■1RZ AND 2RZ ENGINES

■3RZ-FE ENGINE

258HL03

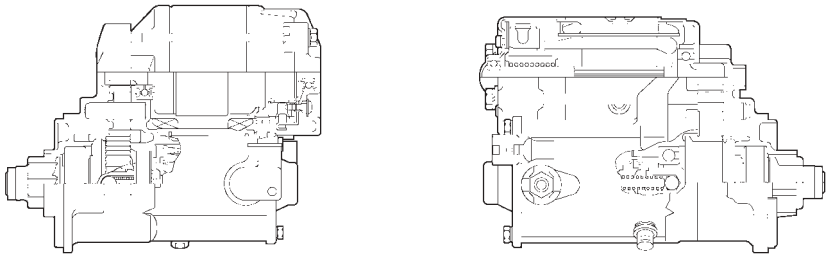
The starter of the 1RZ and 2RZ engine models for General Countries and the G.C.C. (Gulf Cooperation Council) countries has been changed from R1.0 kW to RA1.2 kW in order to improve startability.

New **Previous**

258HL01

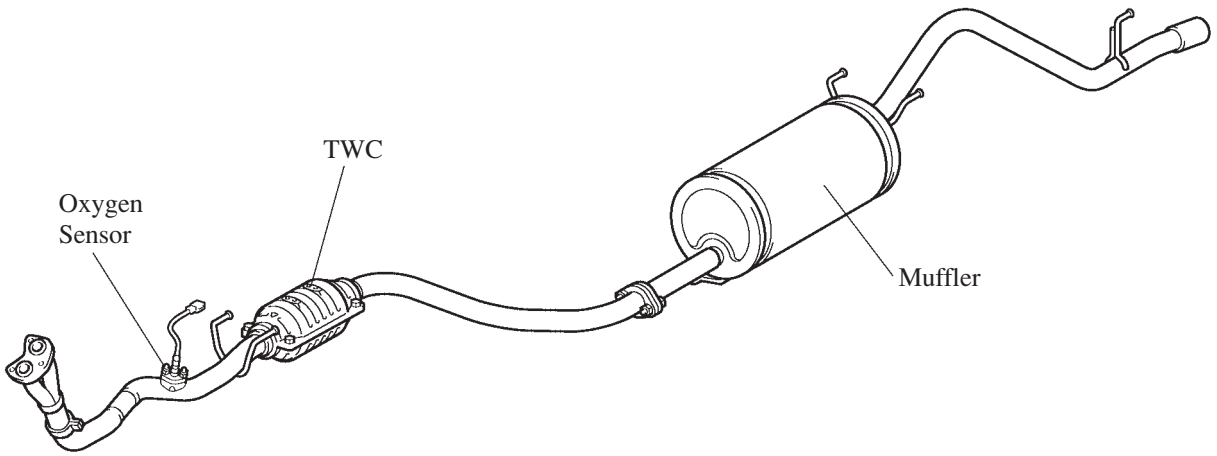
- A thin-wall, ceramic type TWC has been adopted.
- One oxygen sensor has been newly provided in front of the TWC in order to improve the exhaust reduction performance of the TWC through feedback control to the engine ECU.
